**Project #22-058
The Watermark
Located at approx. 1262 West 2200 South**

Project Name: The Watermark
Proponent/Owner: Joshua Low / Watermark Project LLC
Project Address: 1262 West 2200 South
Request: Rezone from COM to MR-30, Design Review Permit
Current Zoning: Commercial (COM)
Date of Hearing: Oct. 27, 2022
Type of Action: Legislative & Quasi-Judicial
Submitted By: Russ Holley, Senior Planner

RECOMMENDATION

CHARACTERISTIC
LANDSCAPE
PLAN

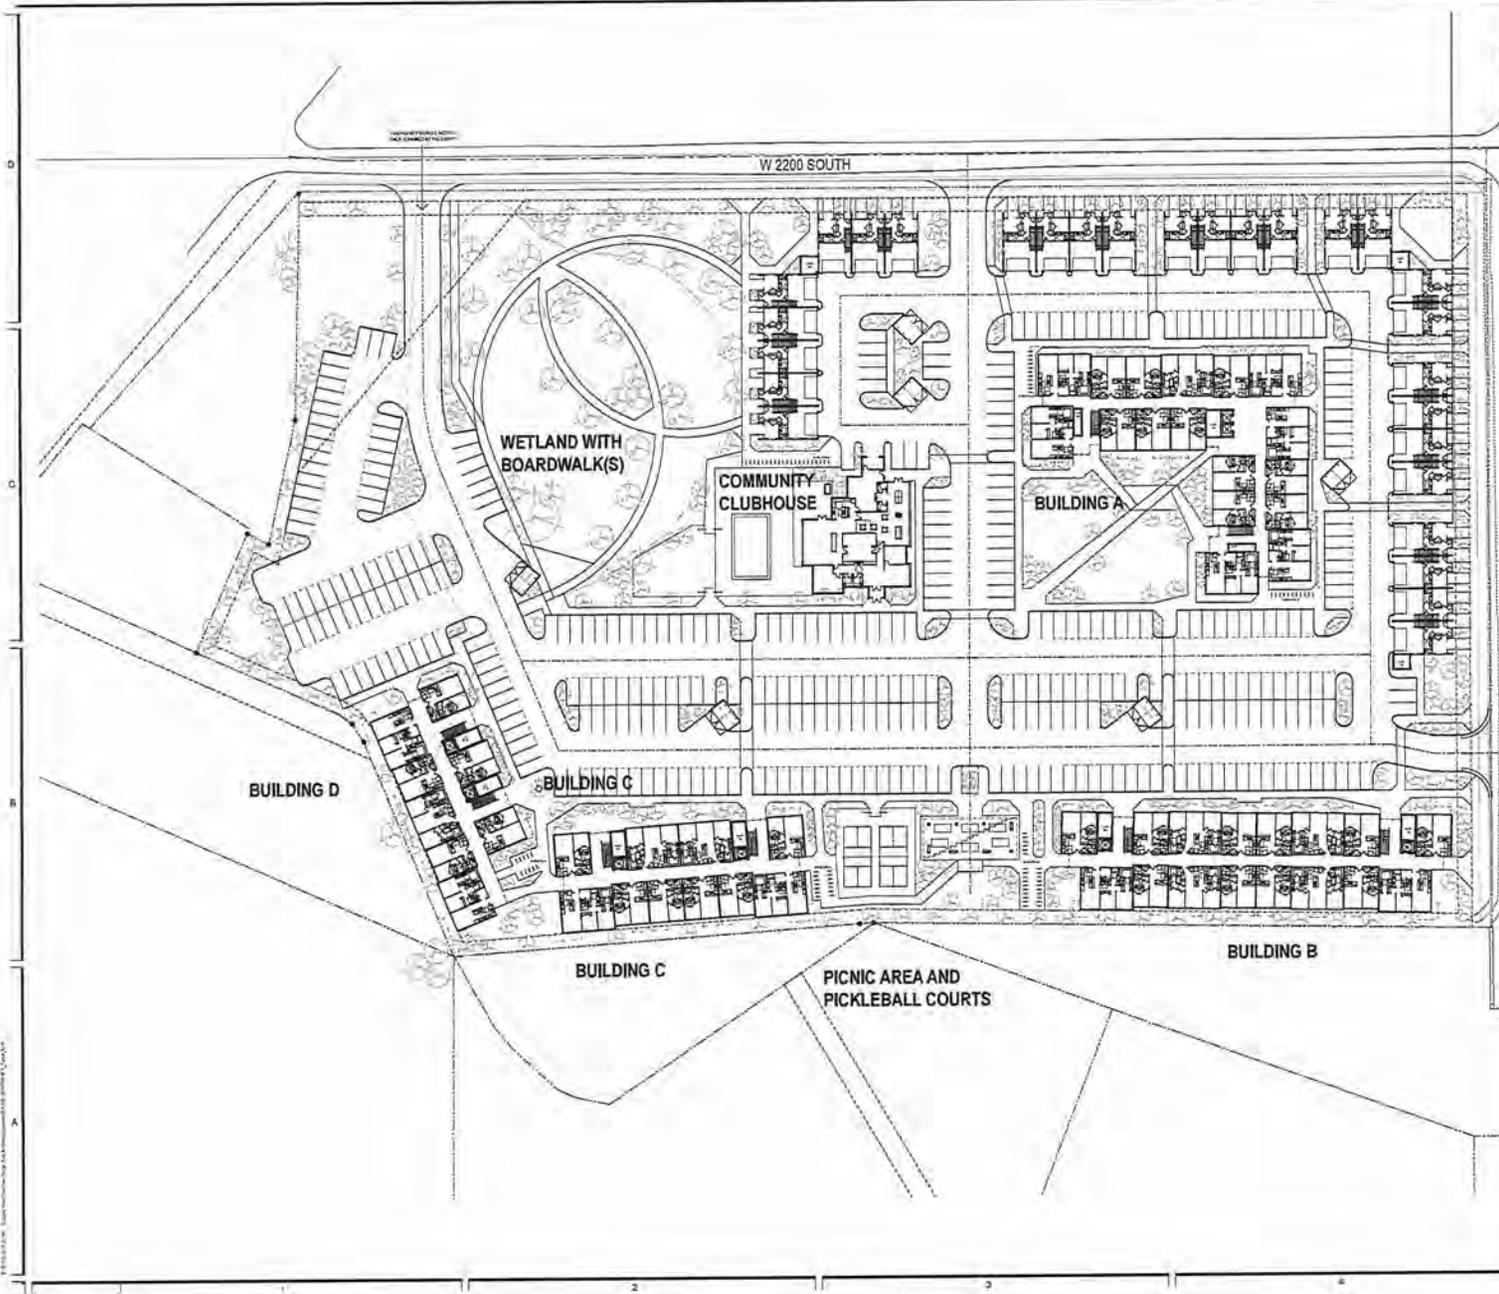
- a. *Fire—contact 716-9515*
 - Current site plan has inadequate fire apparatus access and aerial apparatus access. A fire flow analysis is required to determine available fire flow. Fire hydrants, fire sprinklers, fire alarms, and standpipes will be required.

- The proposed reduction in parking spaces is a significant concern as reduced spaces requires tenants to find creative ways to park, which has resulted in parking issues at similar developments in the City. Considering the distance the development is from the downtown core and the university, the City Engineer recommends that the standard City parking requirements be required.

- The quality of the plans submitted are not sufficient to allow reading of all print and to understand all details. Illegible items shall not be considered as approved.

- Align the 1200 W driveway with 2260 S to the east.

- The minimum full movement access spacing for driveways on 2200 S is 125 feet. The western driveway will need to be separated from the highway by at least this distance.
- A traffic impact study will be required to demonstrate the impacts of the development on the surrounding area. The TIS will be provided by the City at a cost to the developer.

3. Building “B” west façade shall have an entryway and architectural features that look like a front façade.
4. The project shall provide at least 464 parking stalls and bike racks. The submitted alternative parking plan will need to include all required documents as per LDC 17.31 prior to consideration and approval.

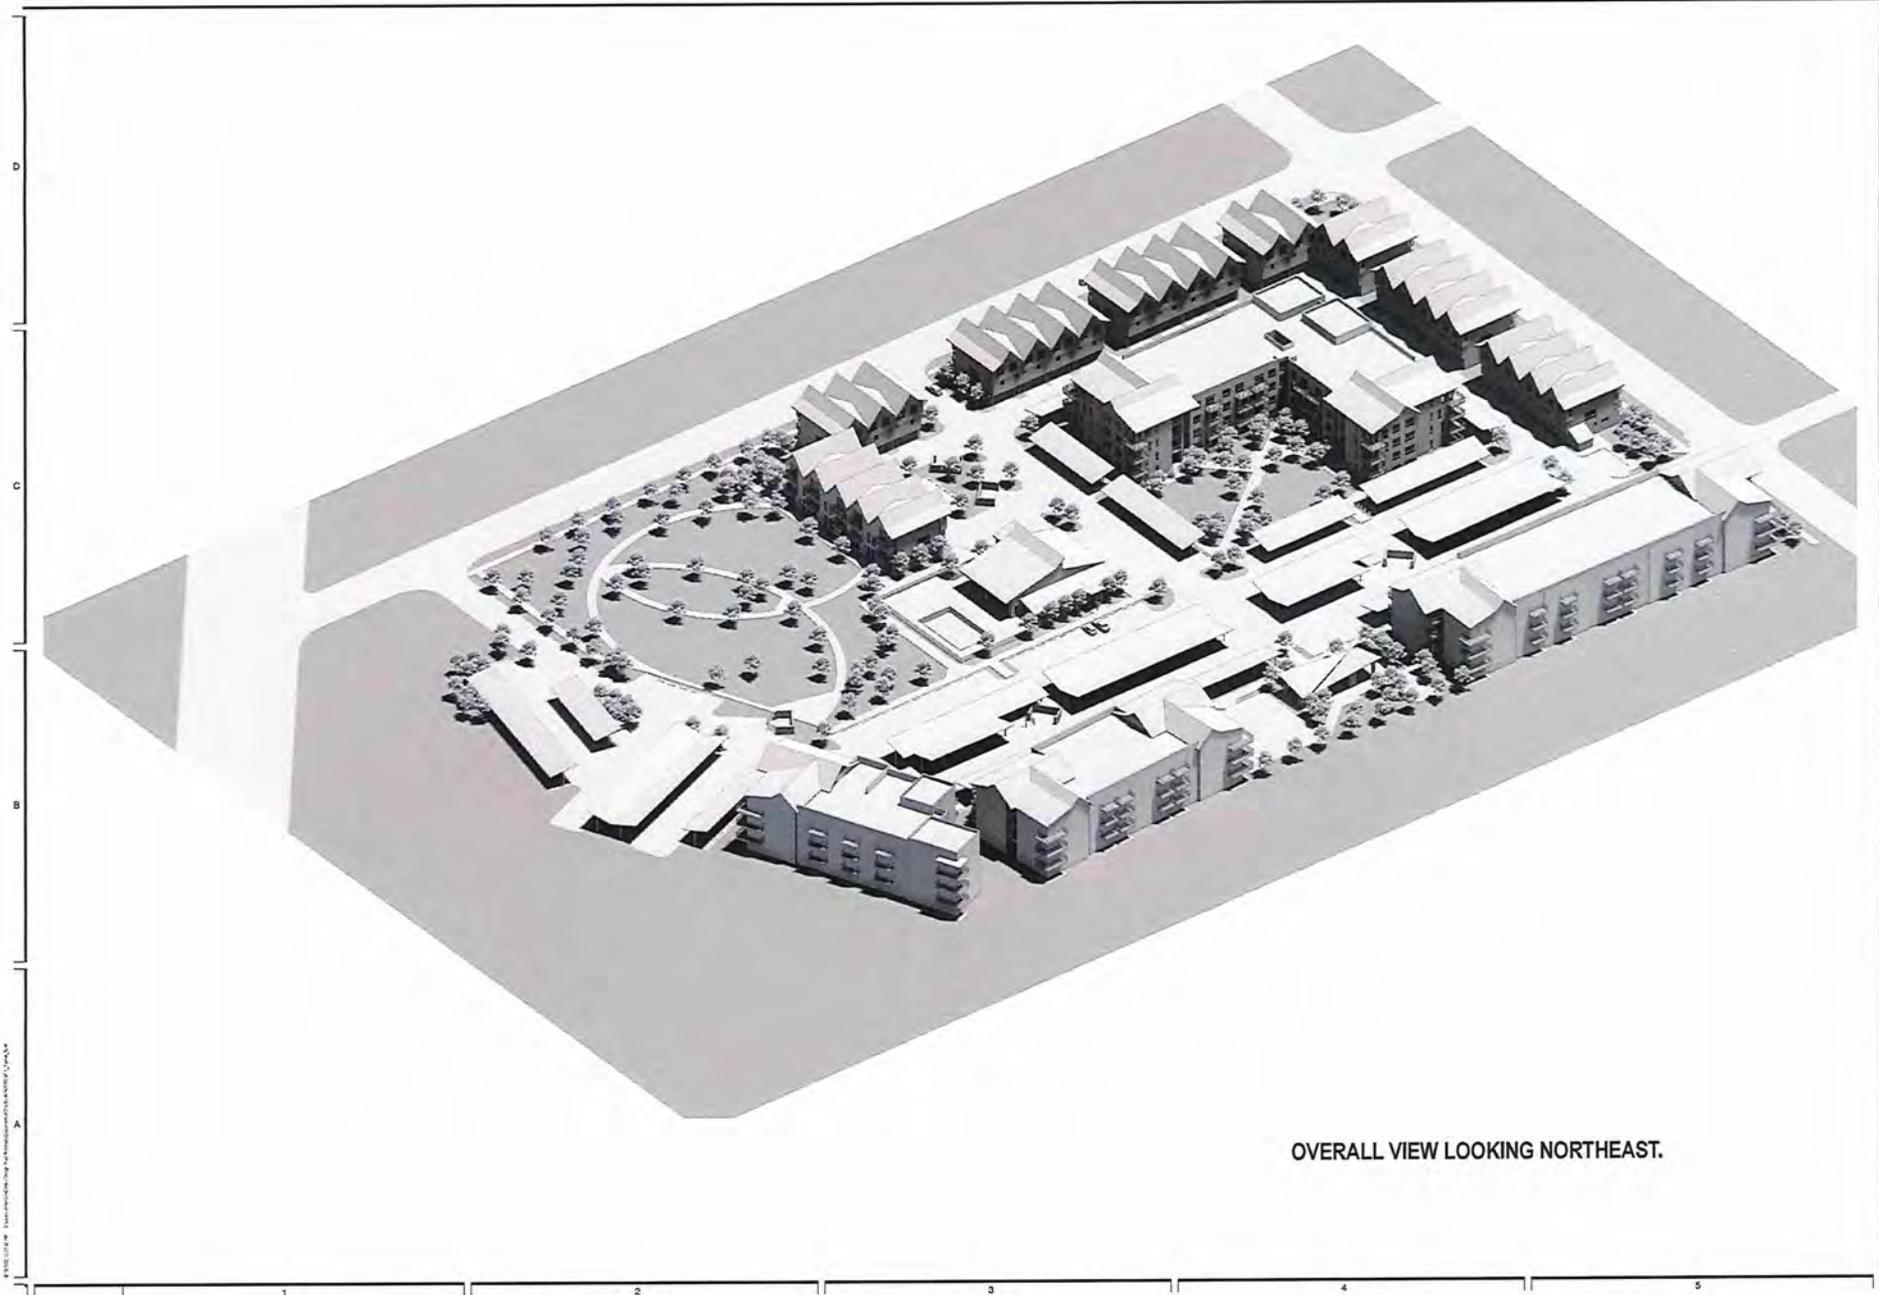
The LDC 17.09.040 requires multi-family buildings to have minimum variations, interesting façade design, a mix of materials and articulation for aesthetically pleasing projects. The MR-30 zones are required to have minimum street-facing façade design variations from adjacent buildings to enhance neighborhood character and create visual interest (limit “cookie-cutter” homes). The LDC identifies eight (8) different categories and requires that at least four (4) out of the eight (8) be noticeably different. The eight (8) categories listed are building color, materials, roofline, height (number of floors), fenestration, architectural style, articulation, and porch design. The townhome buildings show four variations from half of the adjacent buildings/units, but some adjacent townhomes are designed identically. As conditioned with forward orienting architectural features on the west façade of building “B”, and façade variation compliance for the townhome buildings, the project meets the code requirements in the LDC.

1. All standard conditions of approval will be recorded with the Design Review Permit and are available in the Community Development Department.
2. The townhome units shall comply with façade variation standards in the LDC 17.09.040.
